Brocade Fabric OS v5.0.5d

Release Notes v1.0

May 18, 2007

Figure 14-1 Accessing Performance Graphs

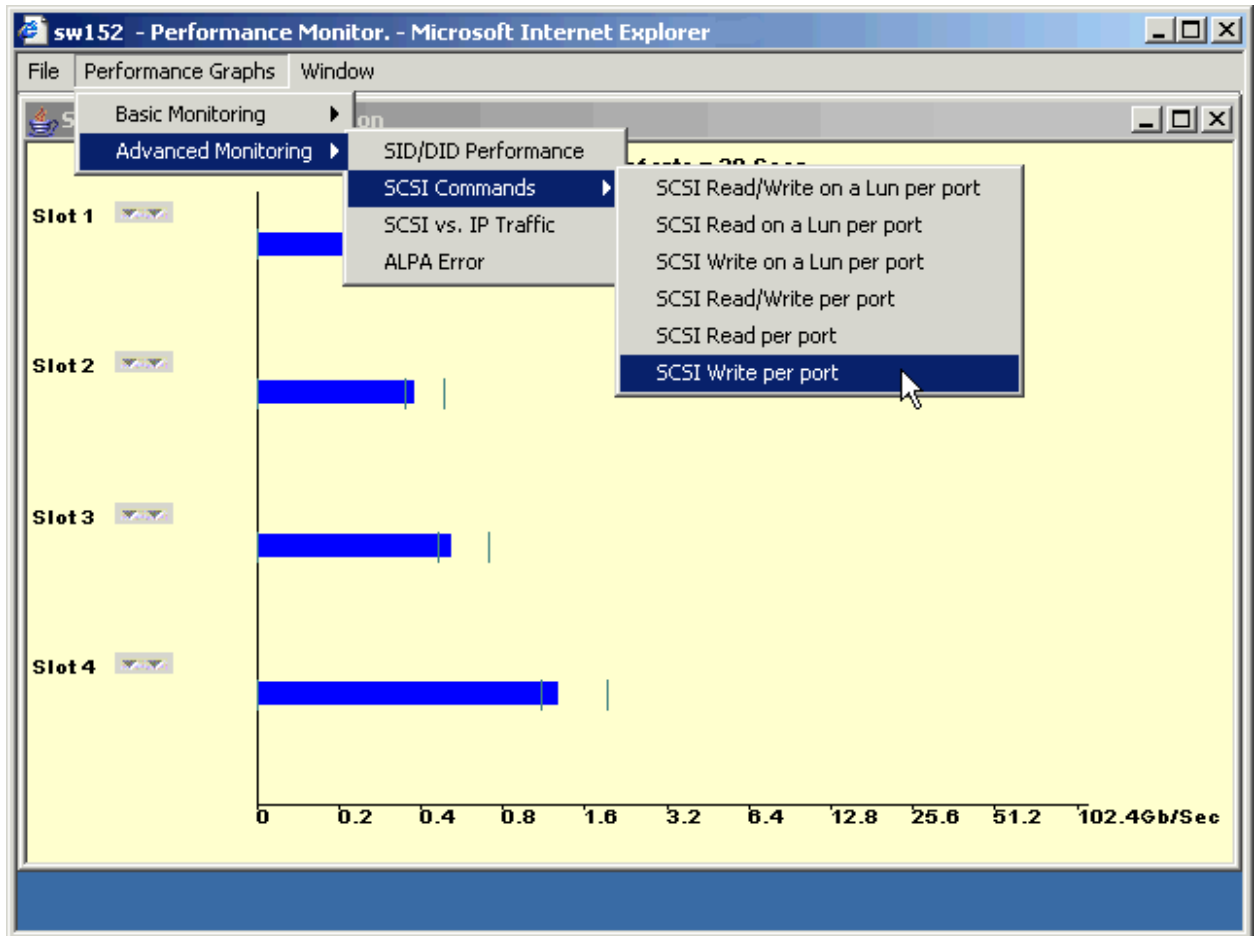
On page 14-3, replace Figure 14-1 with this one:
